March 16, 2021

CERTIFICATE OF APPROPRIATENESS

RE: Application Number 21-7125; 1031 Marlborough, Jefferson Chalmers Historic Business District

E BUILDING ELEVATION – EAST
 A1/A6 1/4" = 1'-0"

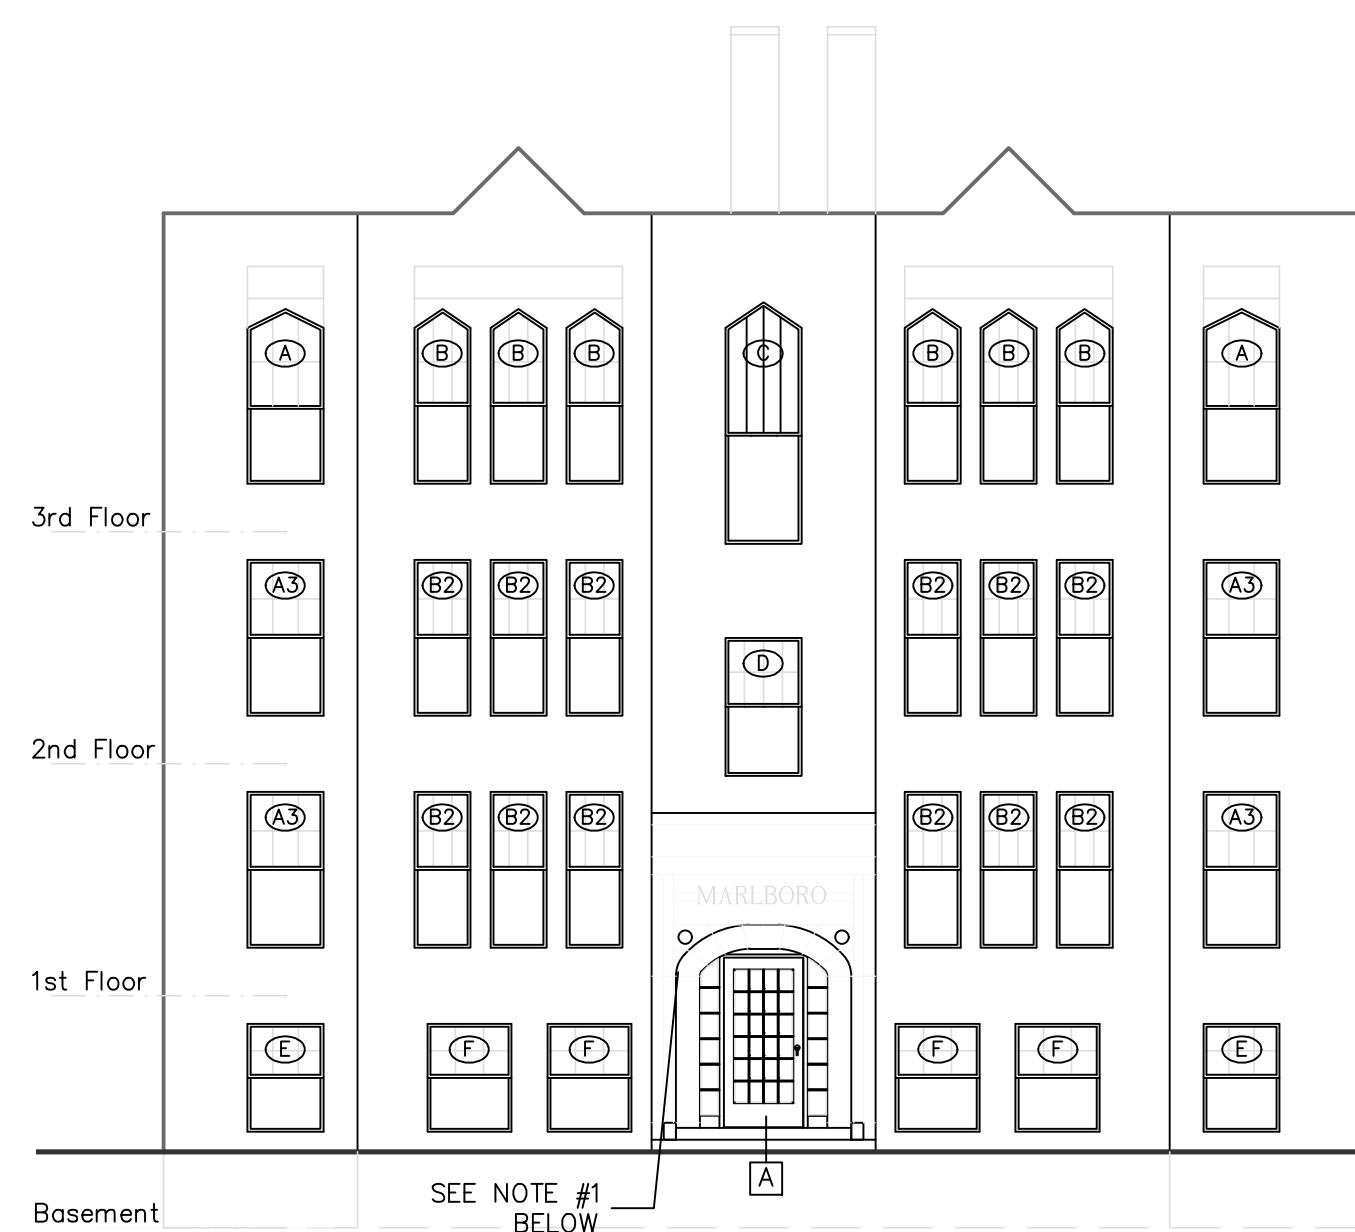
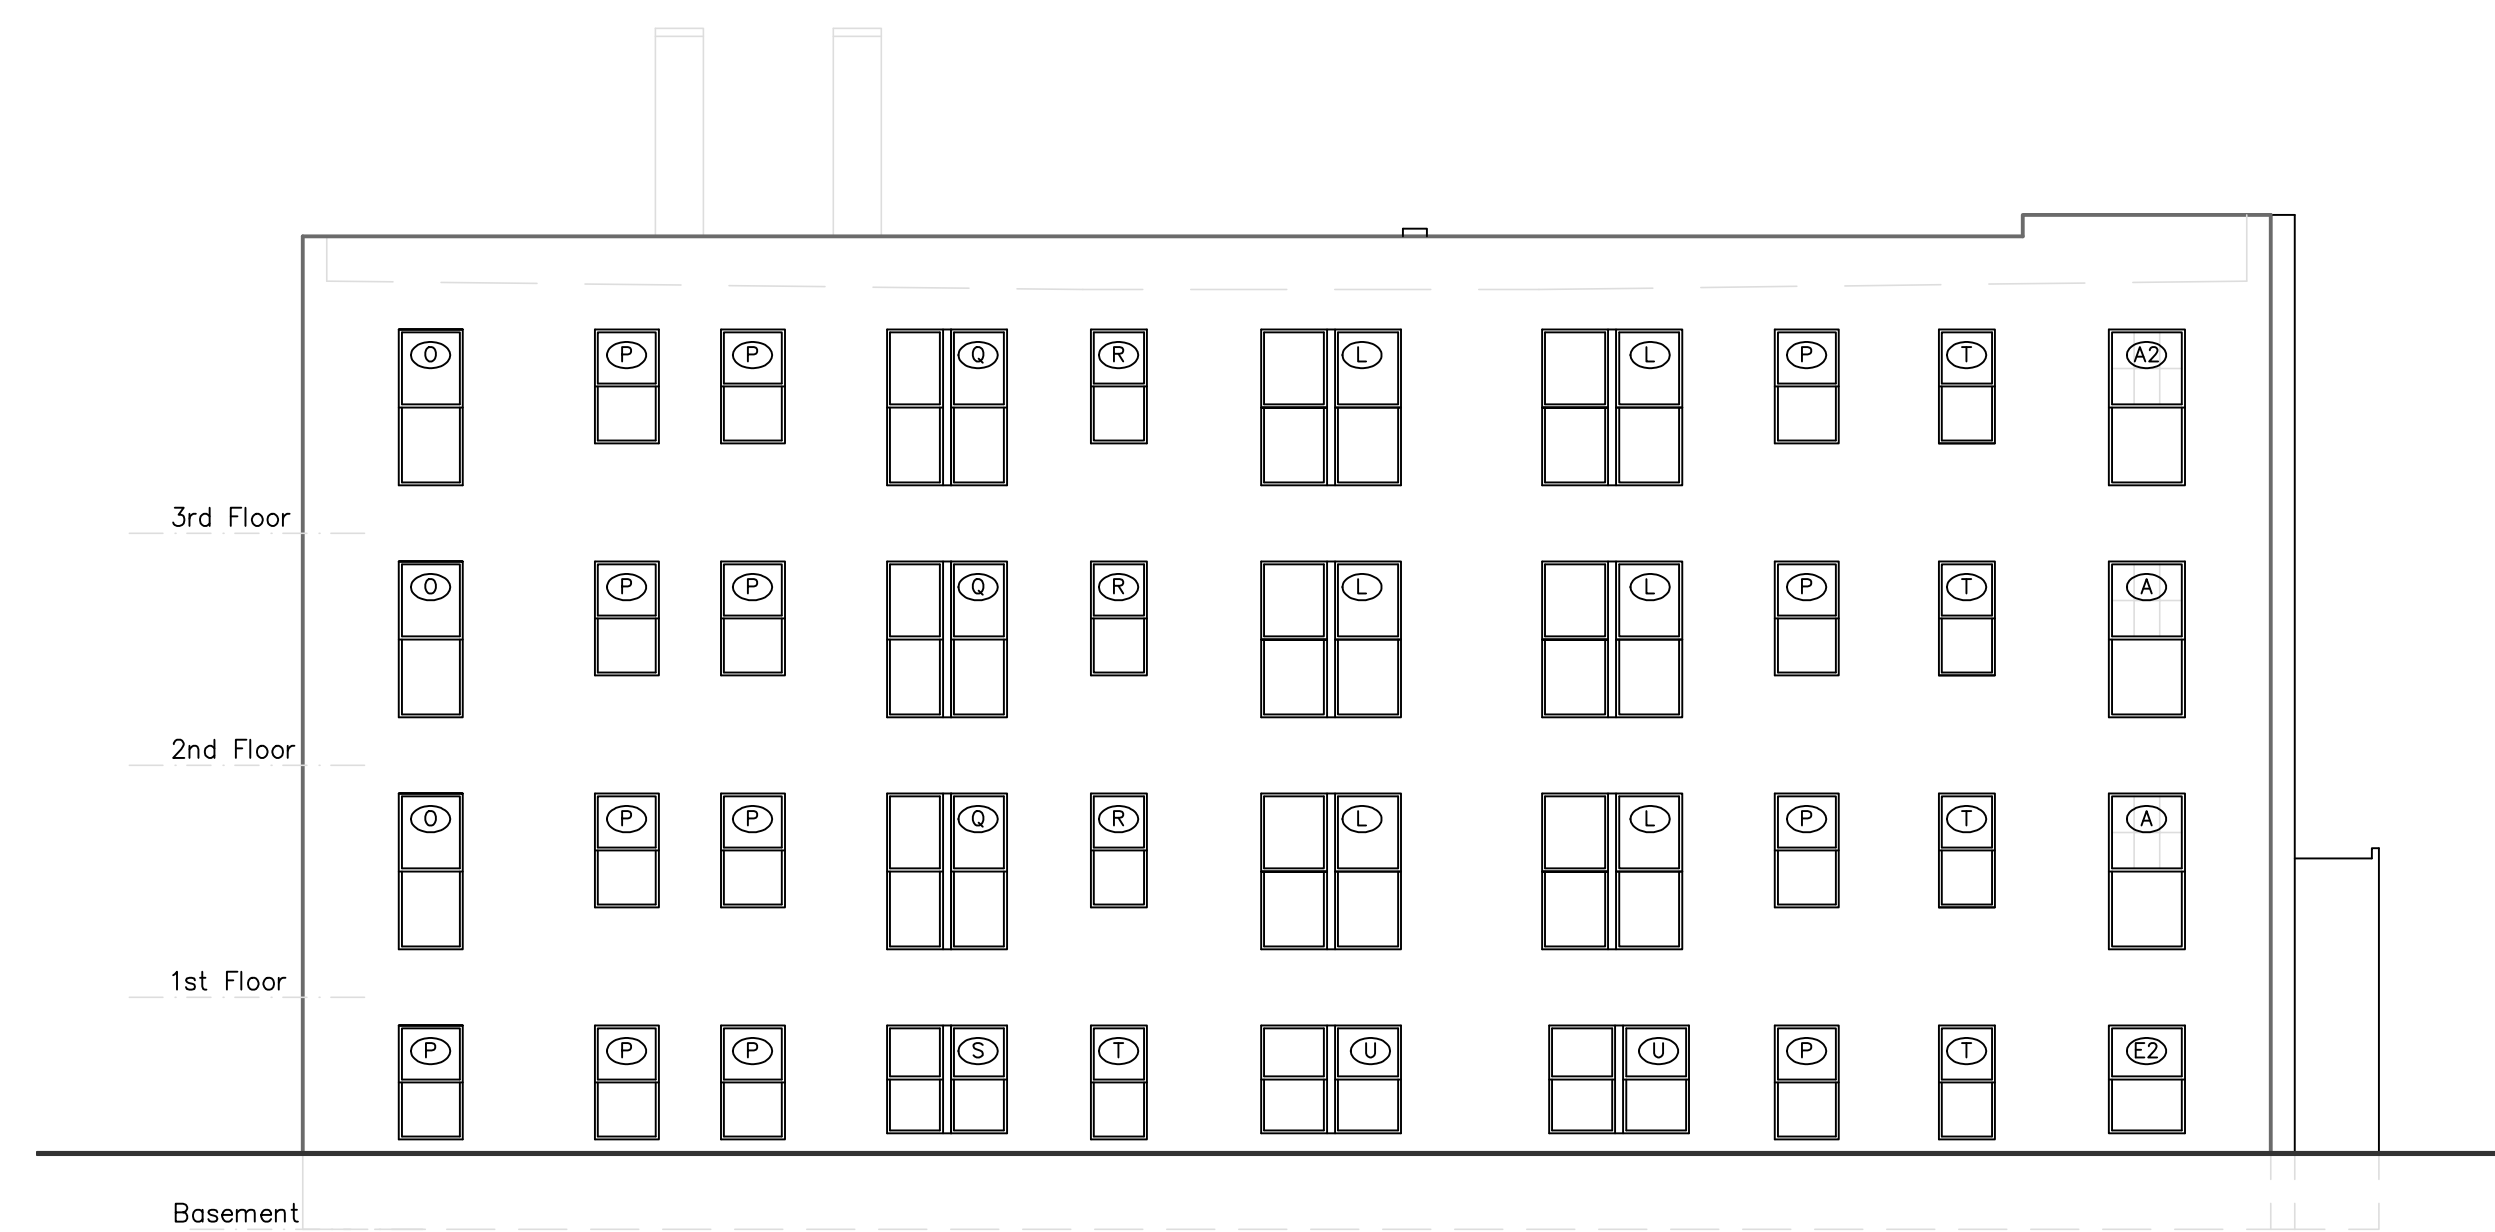
Window Replacement – Construction Set: Page A6, Pella Shop Drawings, Pella Window Order

Pella Reserve Traditional Style Wood Windows, Integral Light Technology, primed exterior (paint color not specified)
It is staff’s understanding the Pella window order was based on measured drawings, created by Quaker Windows in 2017, of the existing historic windows present in the building. Therefore, wider mullions, similar to historic mullions, have been specified.

East/Front elevation

Double-hung are six-over one, eight-over-one (2nd floor landing), twelve-over-one (3rd floor landing)

North/Side elevation, courtyard:

Double-hung units, one-over-one

South/Side elevation, courtyard:

Double-hung units, one-over-one

First bay closest to Marlborough will have six-over-one double-hung units to match front elevation windows

West/Rear elevation

Double-hung units, one-over-one

- Specifications for the entry door (material, stain, divided lights) will be submitted.
- Catalog cuts for the exterior light fixtures (and confirmation of placement) will be submitted.
- The window at the second floor landing, on the front elevation, will be removed and replaced with an eight-over-one double-hung window.
- The window being fabricated for the third floor landing should be confirmed through Pella (and HDC staff informed) that it will be a twelve-over-one double-hung unit.
- The paint color for the window sash will be submitted for review and will conform to the tenants of trim/sash options as outlined in Color System D.
- Confirmation of A/C condensing units and their placement will be submitted. If the units are to be located on the roof, a dimensioned roof plan must be submitted for staff review.
